• A D D E N D U M # 2 •

TO ALL PLAN HOLDERS	DATE	JULY 10, 2015	JOB NO.:	2302-027
	ATTN	Plan Holders		
	RE	City of Newport Abalone and 30th Roadway Improvements

**City of Newport
Newport Abalone and 30th Roadway Improvements
Project No. 2302-027**

CITY OF NEWPORT
 LINCOLN COUNTY, OREGON
 SW ABALONE ST. & 30TH ST.
 ROADWAY IMPROVEMENTS
 UTILITY PLAN & PROFILE - SW BRANT ST -
 STA 6+50 TO STA 11+75
C107
 July 2015

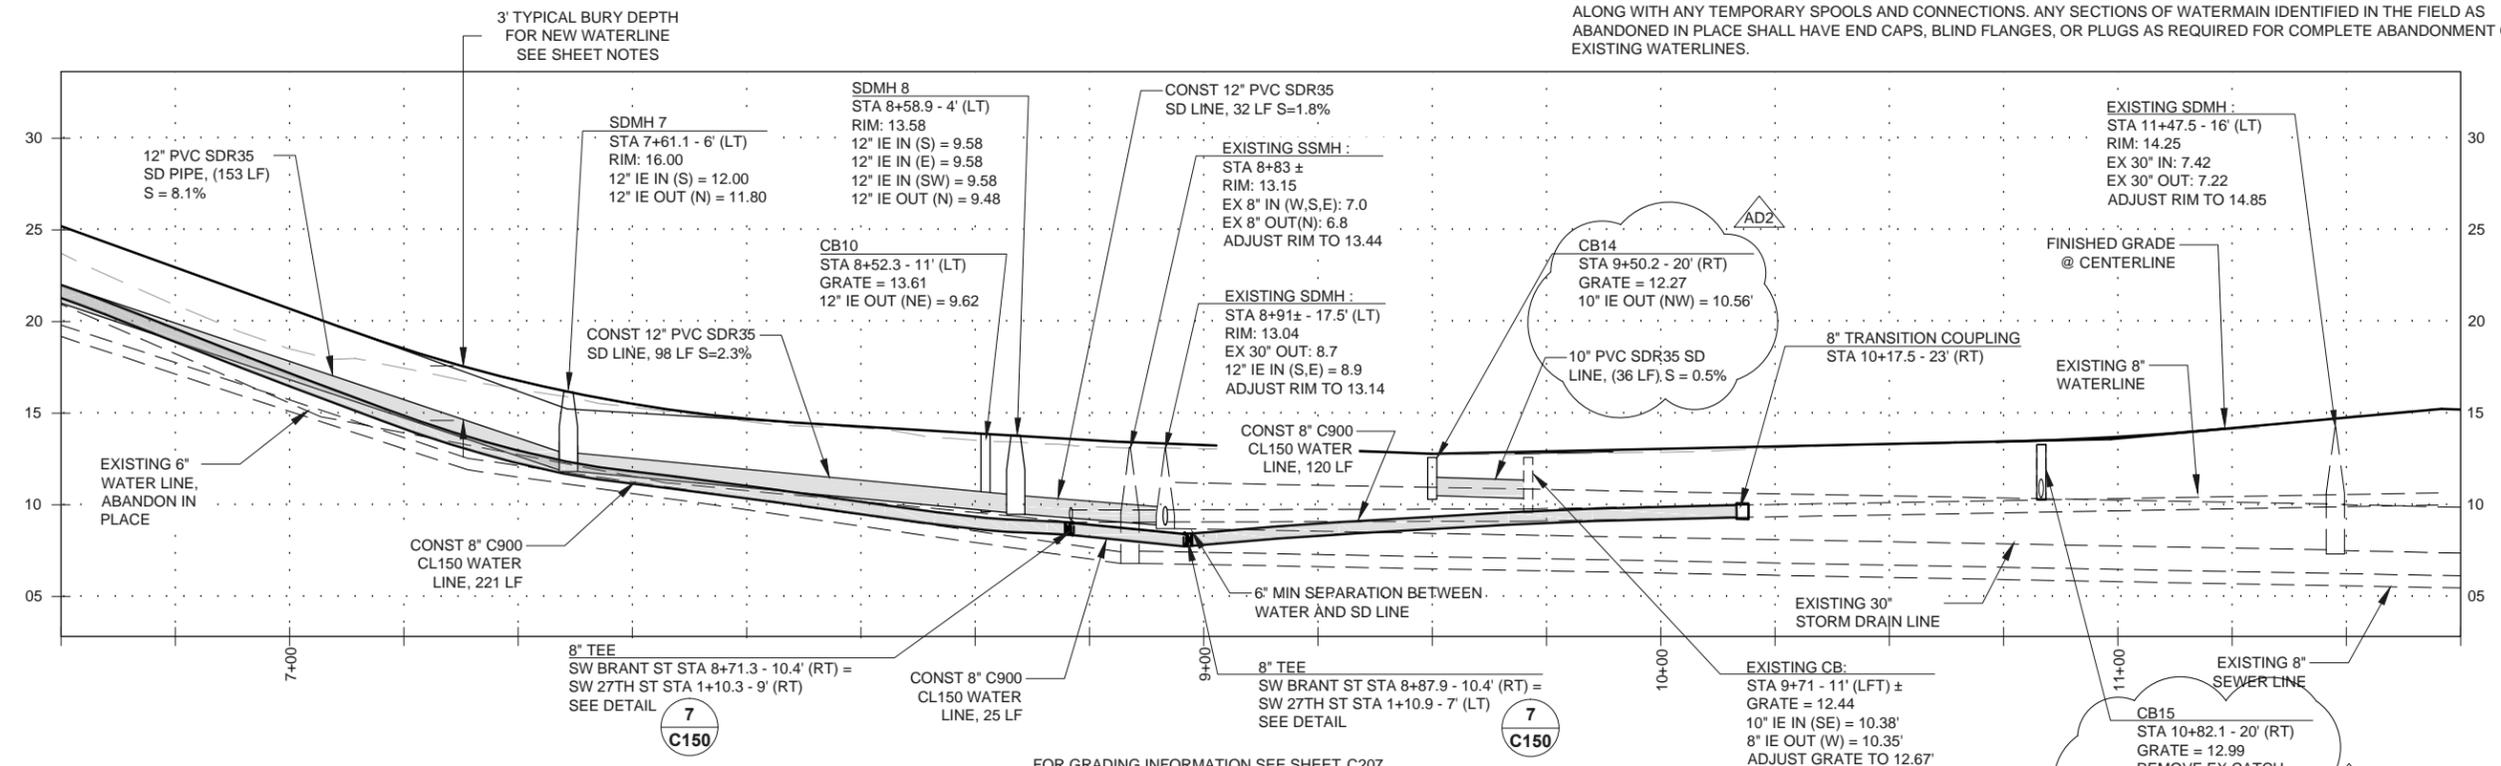
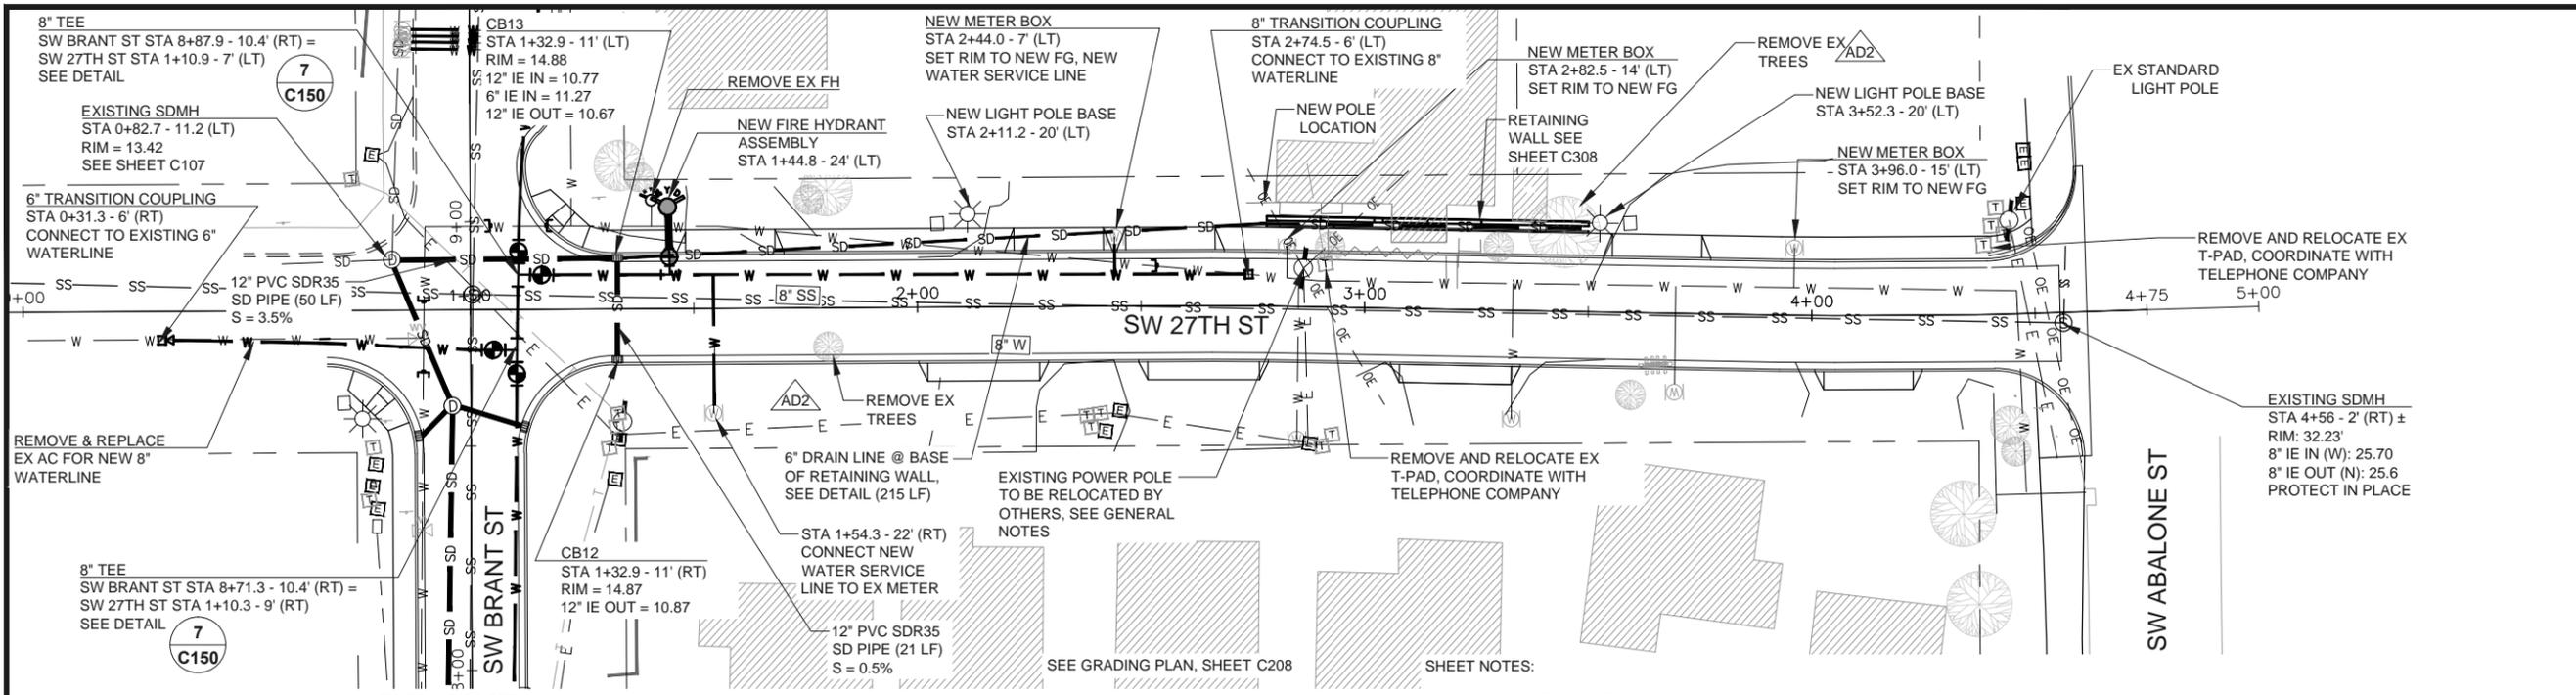
1. C107- Sta 9+50, Replace 30 lf of 12" SD line with **36 lf of 10" SD line and adjust CB 14 East**. At Sta 10+82, Replace existing 10" SD line with **29 lf of 10" SD line and adjust CB 15 East**.
2. C107/C207- Added Parallel parking on the East side of Brant Street between SW 27th and SW 26th Street.
3. C108- Added note "REMOVE EXISTING TREES".
4. C303- Changed retaining wall drainage, added 4" drain rock surrounding perforated pipe wrapped in filter fabric, also added base compaction of 95% MDD
5. C307- Changed retaining wall drainage, added 4" drain rock surrounding perforated pipe wrapped in filter fabric, also added base compaction of 95% MDD
6. C308- Changed retaining wall drainage, added 4" drain rock surrounding perforated pipe wrapped in filter fabric, also added base compaction of 95% MDD
7. E3- Added Joint Trench Detail for placement of new utility lines.
